Published date	30/01/2019
Document number	SUPAIR_2019/01//001
Page number	1 / 2

Product lifespan / usage advice

ALTIRANDO 3

EVOLITE

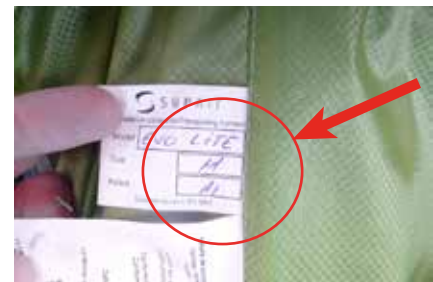
Risk of premature wear :

The fiberglass batten located beneath the seat may, in some instances, pierce the fabric.

The batten was placed inside its sleeve without protection, thus exposing one end with sharp edges.

Version C1.1 has been modified and does not pose a problem anymore.

Version A8.1 has been modified and does not pose a problem anymore.

Remove the batten :

Depending on the pilot's size, the batten may or not be useful.
Conduct a hang-test with and without the batten in place.

Contact us at sav@supair.com to receive a batten with two protective end caps corresponding to your harness model and size.

You can fly without the batten inserted inside the harness (a comfort and personal feeling only). Take care of your harness, and have nice flights!
